Technical Service Bulletin: tsb101652

Capscrew Torque Revision to Cylinder Head Procedure

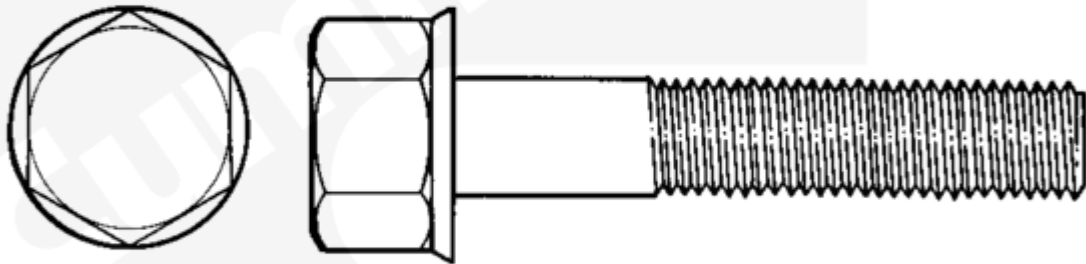
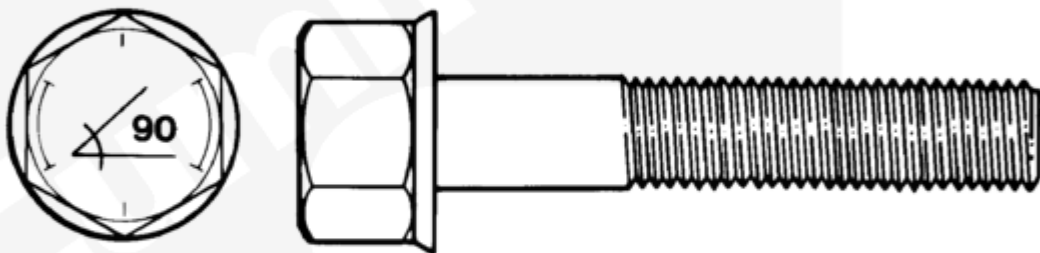
This Service/Parts Topic introduces a new long cylinder hex head flange capscrew, Part Number 4923187, that supersedes Part Number 3045850. This change has been implemented as a product improvement to address capscrew corrosion failures. The Engine Serial Number first is 35124397.

The new capscrews can be mixed with the old capscrews.

The new capscrews have a grey coating on them and do **not** have the 90 degree marking on the head of the capscrew.

New capscrew 4923187

Old capscrew 3045850
